Lot. 58, Sub. 4, S.S. No. 23
 W.B. Carter Constr. Co., Inc.
 Proj. No. C 26-62, Bk. K-85, April 1968

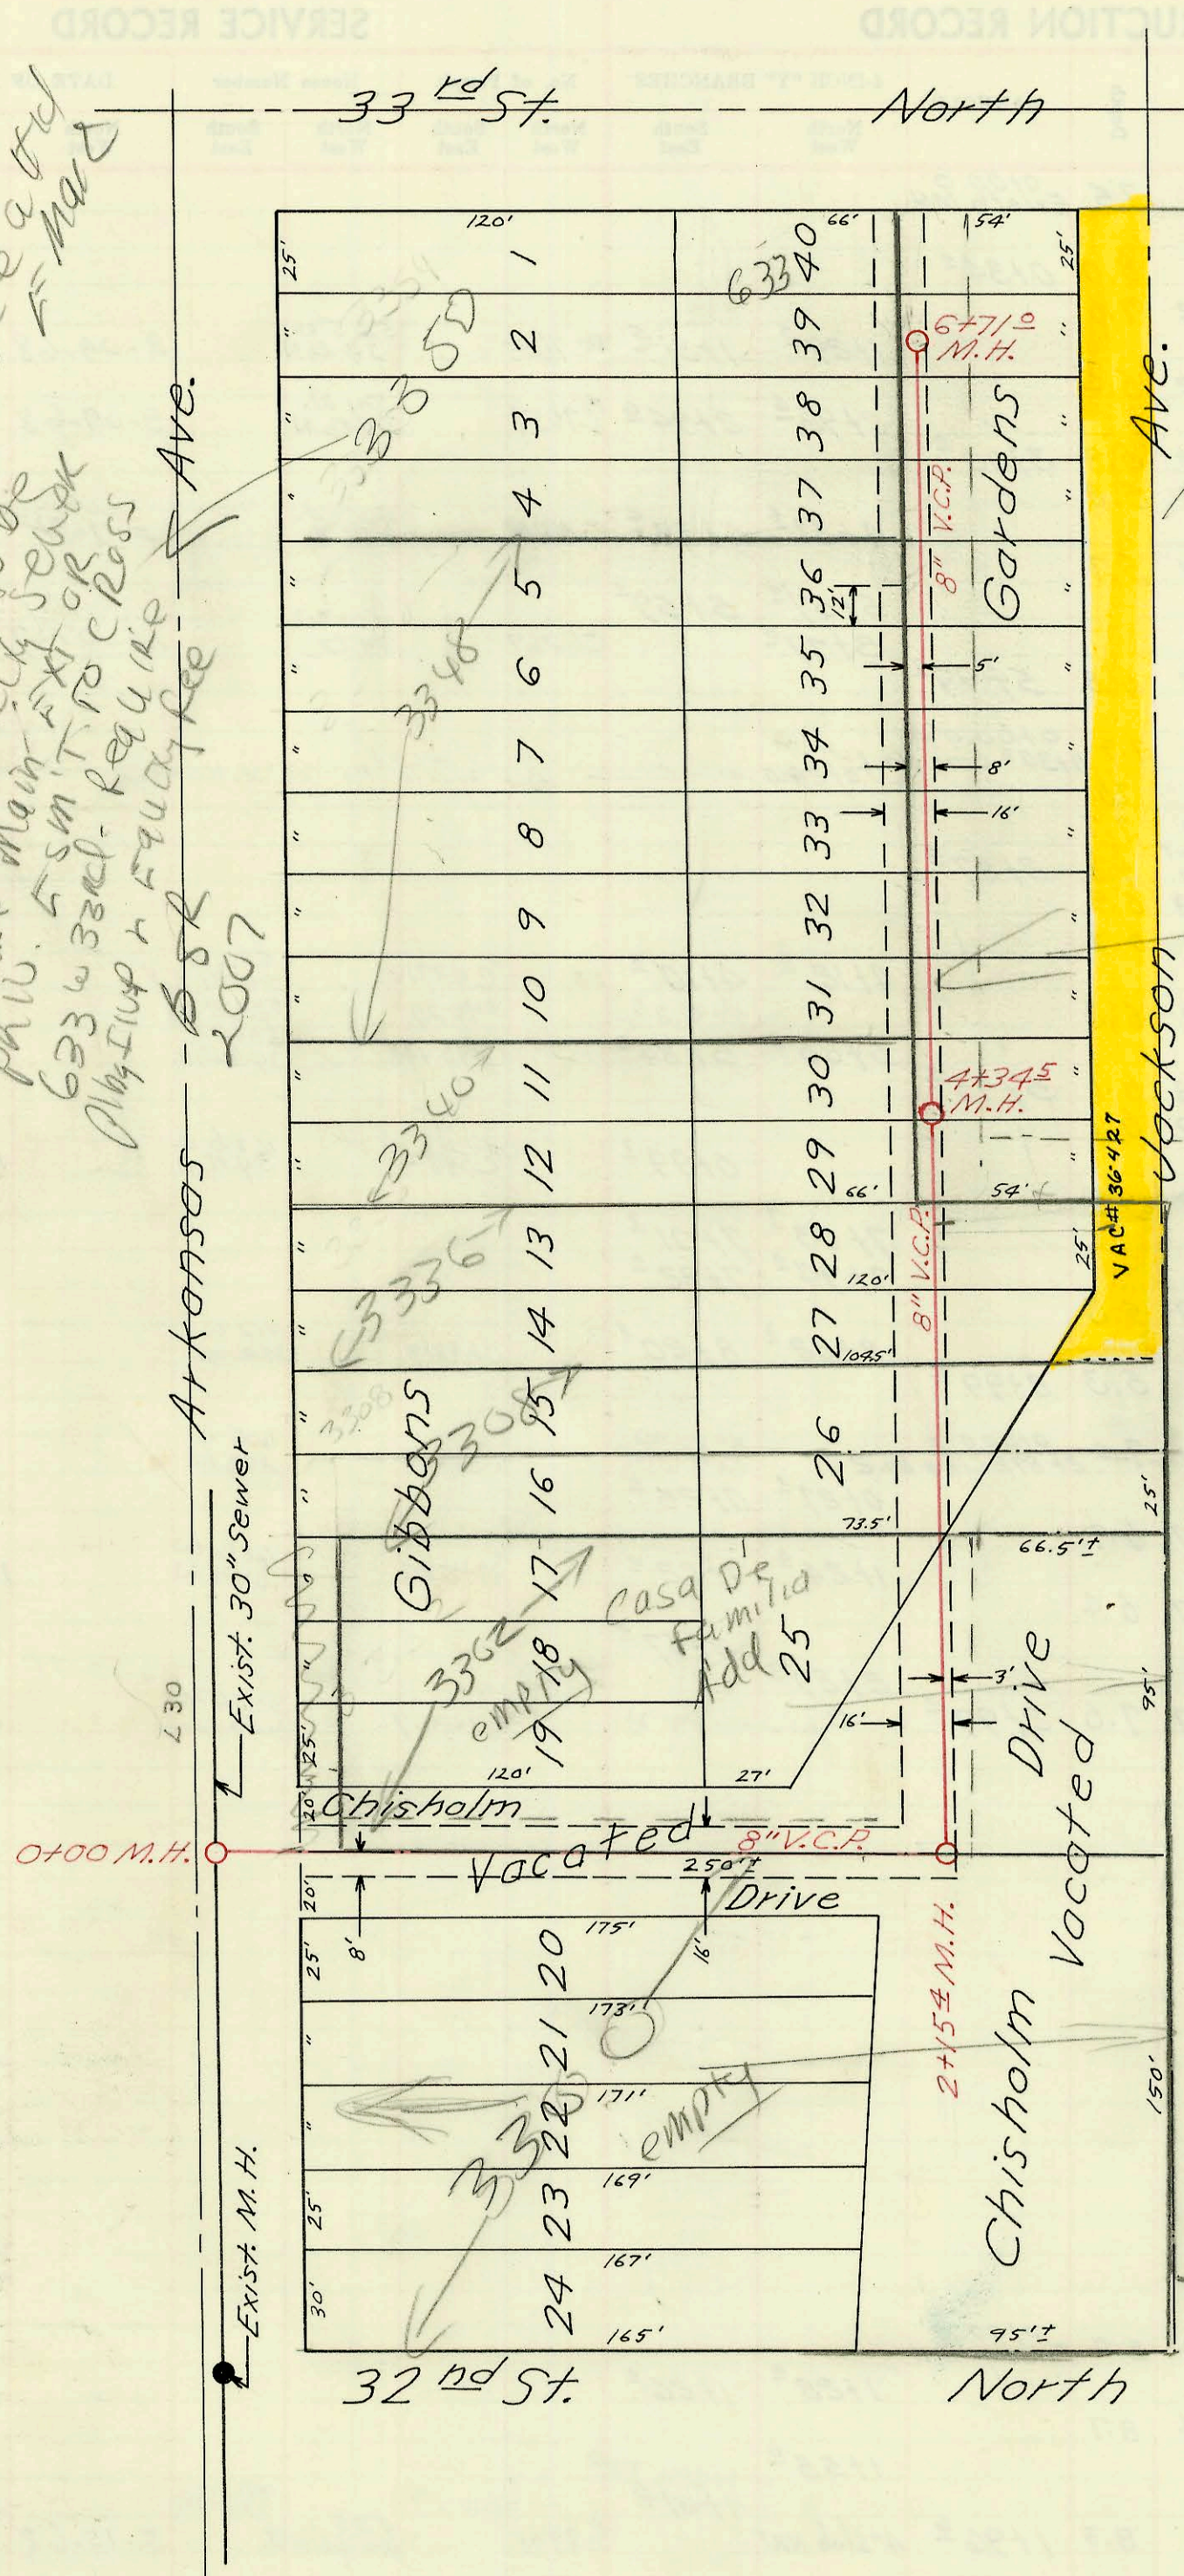
3350 N Arkansas - see attached
 Does NOT appear to be
 connected to City Sewer
 Require main EXT sewer
 P.W. 5 SM.T. TO CROSS
 633 w 32nd - require
 1/2" dip & equal fee

Refer to
 Savina 4th
 Add
 Maybe a
 8" V.C.P.
 Line
 375-02
